Master Plan Site # 23/103 John D. Berry House  
17201 Palomino Court, Olney

SUBJECT: Historic Area Work Permit #450671, chicken coop demolition

**MONTGOMERY COUNTY HISTORIC PRESERVATION COMMISSION**  
**STAFF REPORT**

**PROPOSAL:** Chicken coop demolition

John D. Berry House 23/103  
172d Palomino Court, Greer  
Chicken Coop

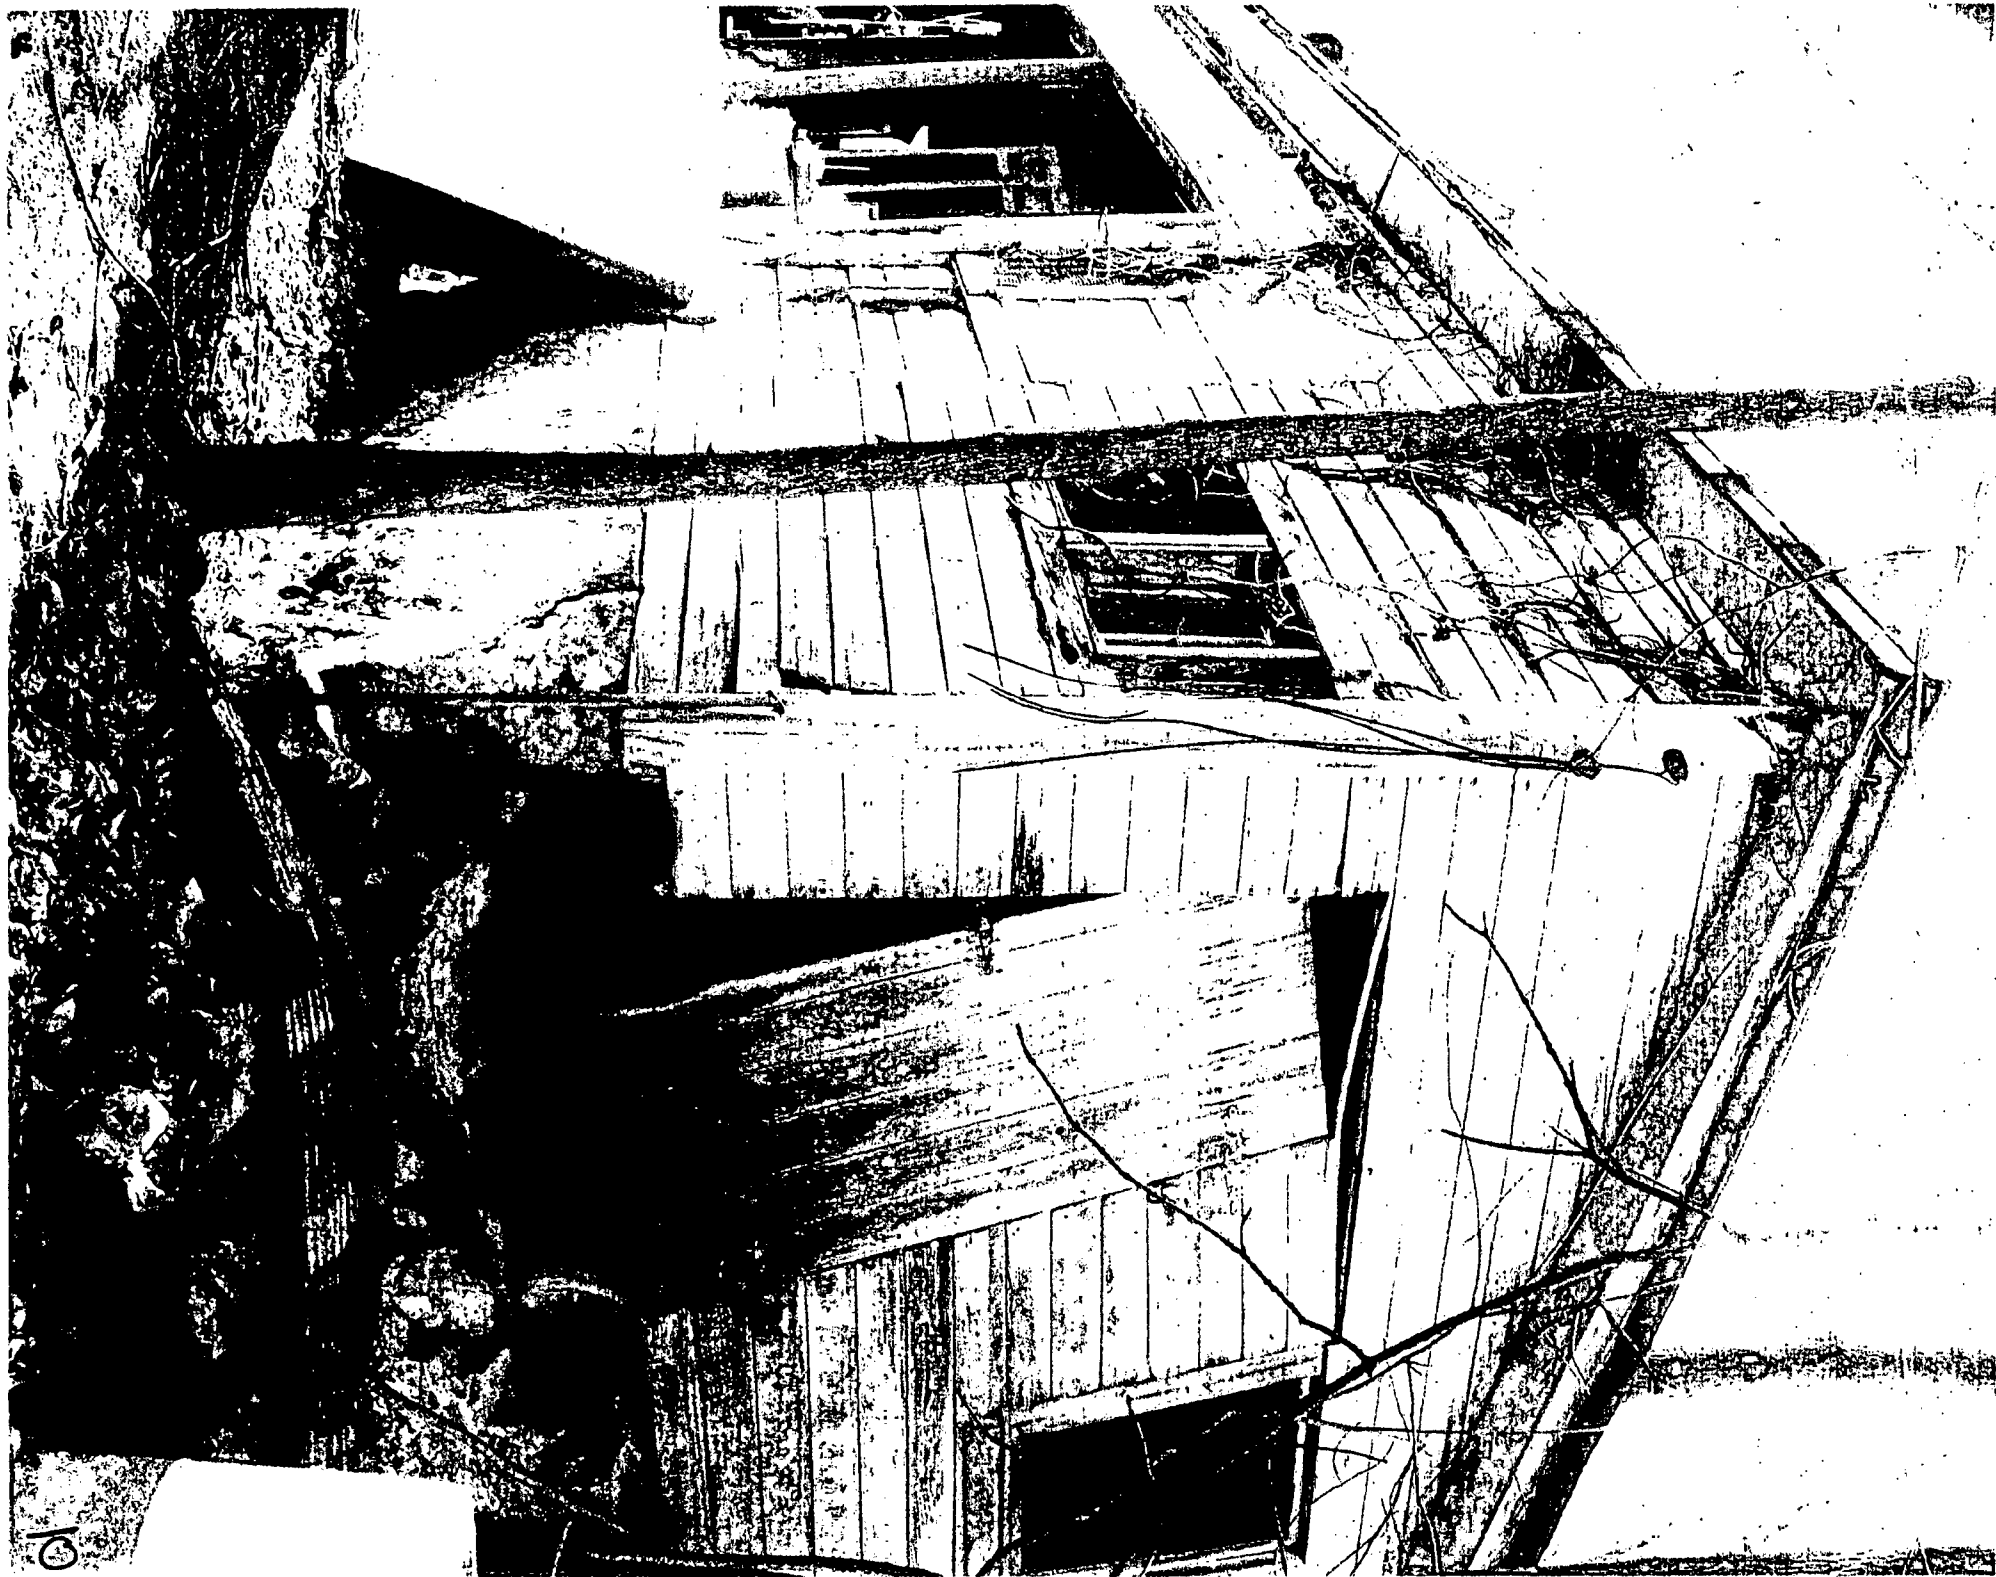
I HAVE INSPECTED THE HOUSE LOCATED AT 17201 PALOMINO COURT IN OLNEY, MARYLAND. TO ACKNOWLEDGE THE "CHICKEN COOP" IN THE REAR OF THE PROPERTY IS STRUCTUALLY NOT SOUND AND SHOULD BE REMOVED IMMEDIATELY. THE BUILDING, AS IT STANDS NOW, IS DANGEROUS FOR ANY INDIVIDUAL ON THE PROPERTY AND SHOULD BE REMOVED.

Of the remaining outbuildings: the silo, carriage house, concrete equipment building, and chicken coop; the chicken coop is in the state of most disrepair. Although the chicken coop is not beyond the possibility of being rehabilitated, staff believes rehabilitation would require a considerable expense to return the building to a functional space. Based on staff site visits it has been determined the chicken coop was built in the later part of the early-20<sup>th</sup> century, which is outside of the period of significance as defined when John D. Berry owned the property (1863-1906). The structural condition of the chicken coop was documented by a building inspector in March 2007 as structurally **not** sound. It was recommended the building be removed immediately. (See page: 14).

Staff is recommending that the HPC approve this HAWP application for the removal of a chicken coop located on the property of *Master Plan Site #23/103 John D. Berry House*.
